WIRELESS SET, BURNDIPT BE 201

TECHNICAL HANDBOOK - MISCELLANEOUS INSTRUCTION

Amendment to Designation Plates

SUB-TITLE: Power supply unit, No 42 - Replacement of changeover contactor

Fig 1 - Drilling details

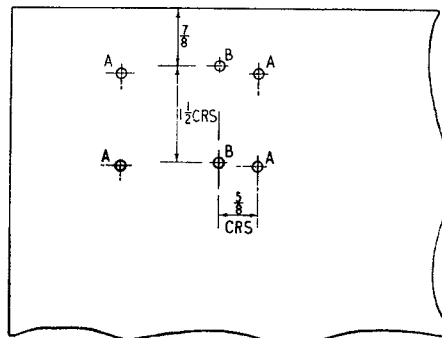
1. The existing generator change-over contactor RLB in the Power supply unit, No 42 (P.S.U. 42) is designated: ZA 31996 - Contactor, 25 amp, No 2. This component is now no longer manufactured, and when existing maintenance stocks are exhausted, it will be replaced by ZA 56881 - Relay, armature, 250V, 30 amp., 12V, 0.32 amp., 37.5Ω coil, which is not directly interchangeable with the existing type. This regulation gives details of the action necessary when the new type relay is to be fitted to the PSU.42 for the first time.

2. When relay RLB on PSU 42 is to be replaced by a component of Part No ZA 56881, and the item removed is of Part No ZA 31996, carry out the following action:-
- (a) Remove the chassis side plate of the psu which is nearest the contactor RLB.
 - (b) Unsolder all the leads from the existing contactor ZA 31996 and remove its fixing screws, nuts, washers and spacers. Remove the component from the chassis. Retain two of the No 4 BA full nuts and two shakeproof washers.

- (c) Mark out and drill two 0.156 in. dia holes on the underside of the chassis in the positions given in relation to the existing four fixing holes, at Fig 1.

- (d) Solder No 4 BA soldering tags (Z2/5940-99-972-7304 - Terminal, lug, No 4 BA hole, x 1/2 in. long, O/A) to the six leads disconnected at (b).
- (e) Using No18 S.W.G. tinned copper wire, connect each pair of terminals on the new relay together, excepting the two coil terminals. The wire used to connect the two armature terminals will be connected, also, to one terminal of the operating coil.
- (f) Position the new relay on the chassis with the larger terminal board towards the front panel of the psu. Reconnect the leads to the relay to agree with the appropriate (relay) part of the circuit at Fig 1003 of Tels F 782.
- (g) Secure the relay to the chassis using two No 4 BA x 1/4 in. long screws (Z2/5305-99-999-4319 - Screw, BA, brass, F.E.H., No 4 x 1/4 in. long, nickel plated) and the nuts and shakeproof washers retained at (b). Reassemble the chassis side plate to the chassis.
